ITEM 8 - WAHL SUBDIVISION

KPB File No.	2022-092R1
Plat Committee Meeting:	September 26, 2022
Applicant / Owner:	Beverly A Wahl of Sterling, AK
Surveyor:	John Segesser / Segesser Surveys
General Location:	Adele Avenue, Robinson Loop Road, Montgomery Avenue, Sterling

STAFF REPORT

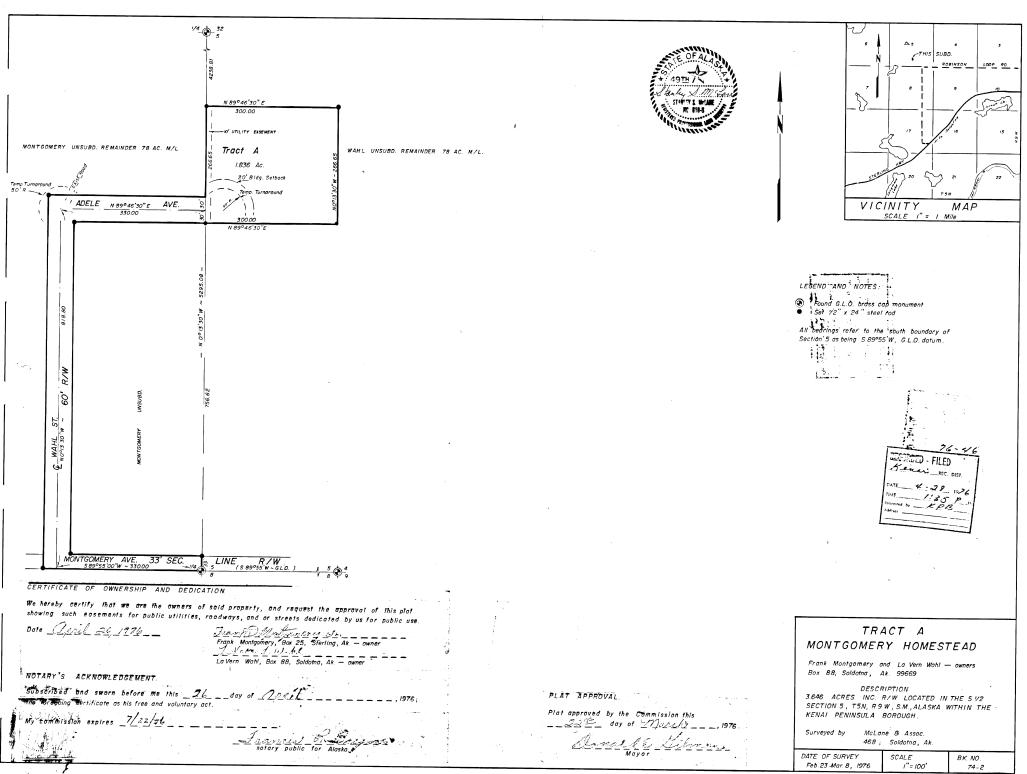
- On the drawing, reference to note 7, should be 9.
- The utility easement detail should be reviewed as the depiction appears to be missing information or not labeled correctly.

Staff recommendation: Revise legal to include Tract A, add R1 to end of the KPB number.

- **Staff recommendation:** Add ROW width to Adele Avenue, Montgomery Avenue to the west, Robinson Loop Rd to the east. Depict and label the adjacent section line easements where dedications have not been granted.

- **Staff recommendation:** Include Tract A in the darkened area.
- E. All parcels of land including those intended for private ownership and those to be dedicated for public use or reserved in the deeds for the use of all property owners in the proposed subdivision, together with the purposes, conditions, or limitations of reservations that could affect the subdivision;

- **Staff recommendation:** Provide an additional dedication label for the wider portion of Montgomery Avenue as that portion is not 33 feet in width.

Staff recommendation: Parcel in southwest corner from plat needs label. Parcel to the east of plat needs correct plat reference

Staff recommendation: On Montgomery Homestead KRD76-46 is shown a 20 foot building setback line going around the temp turn around.

Staff recommendation: Add a wastewater disposal note for Tract A1. Comply with 20.40.

Staff recommendation: make the lines for Tracts A1 and Tract C lighter

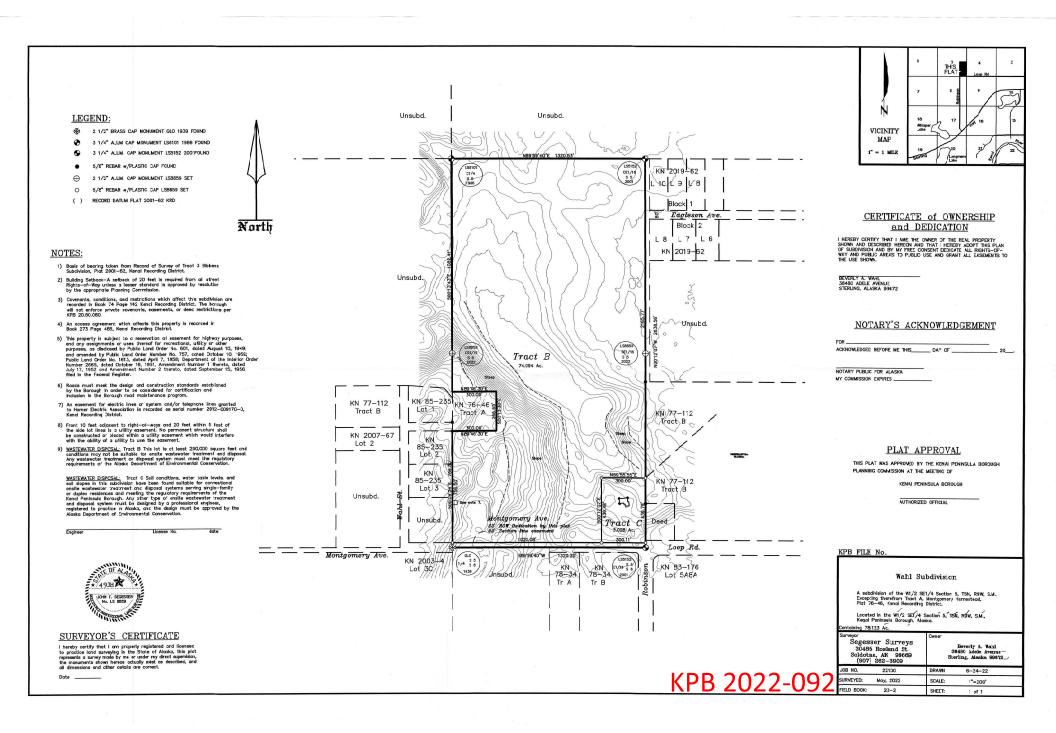
- Any rights-of-way being shown should include a width label.
- There is an overstrike on the Wahl Street label.
- Provide a street name label for Adele Avenue in addition to a width label.
- The unsubdivided parcel to the northwest is Tract 2 of KN 84-328.
- The unsubdivided parcel to the east is Lot 3A Block 1 of KN 2006-24
- The northern Tract B to the east is Tract A-1 of KN 2006-70.
- The southern Tract B to the east is from KN 2004-82 and miscellaneous text appears within the lot boundary.
- Lot 3C to the southwest is Lot 3-C.
- On the vicinity map, place the site in the correct location.
- Correct the drawing of KN 85-235 Lot 1 as needed.

Correct plat note 3 code reference, should be 20.60.170.

Get complete copy of easement referenced in Book 273 Page 486 to correctly show location of easement.

Staff recommendation: There is a typo within the certificate of ownership and dedication. Comply with 20.60.190.
